SUNDRY NOTICES AND REPORTS ON WELLS

8. Well Name and No.
HAWK B-1 09 WBDU #39

WBDU 39W (API: 30-25-06441) Proposed Procedure

Conditions of Approval

Apache Corporation
WBDU #39W (Hawk B-1 #9)
WELL DIAGRAM (PROPOSED CONFIGURATION)

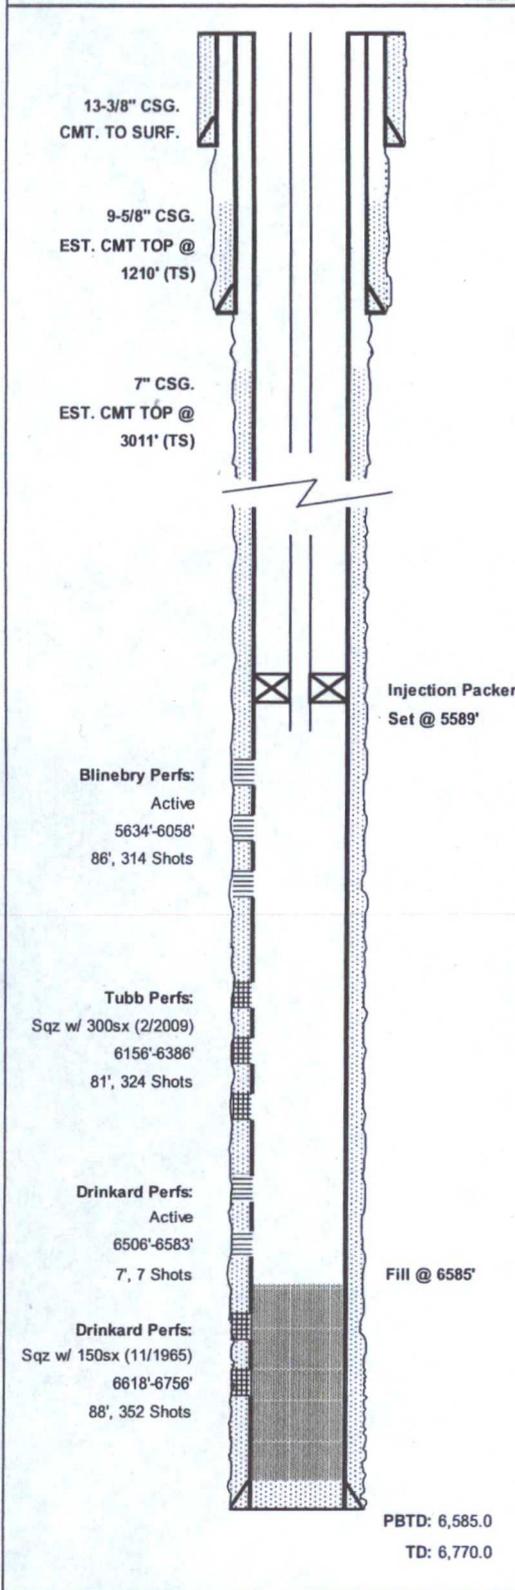
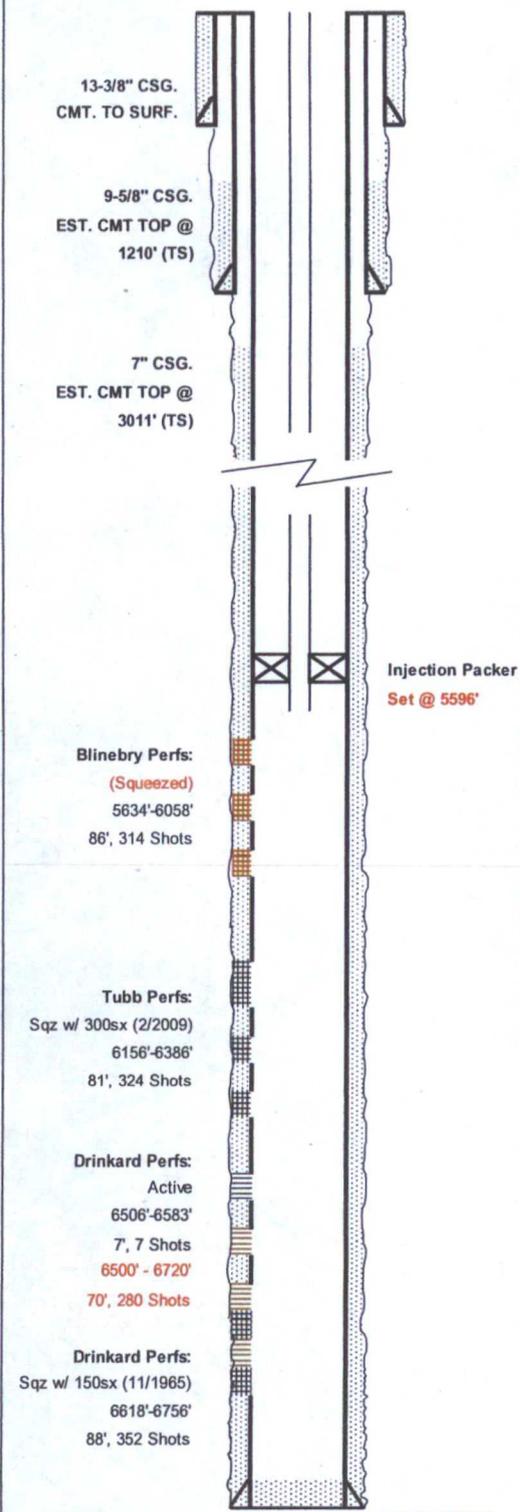
After meeting with the BLM concerning our waterflood program, Apache would like to amend our procedure to recomple in the Drinkard portion of the formation, per the attached. This work will be completed within the next 6-12 months. Current and proposed WBD's are also attached.

Squeeze Blinebry perforations, clean out well, recomple and stimulate Drinkard

3. Subject to like approval by the New Mexico Oil Conservation Division.
- 4. Provide BLM with an electronic copy cement bond log record of the 7" csg from 6100 or below to top of cement taken with 0psig casing pressure. The CBL may be attached to a pswartz@blm.gov email. The CFO BLM on call engineer may be reached at 575-706-2779.**
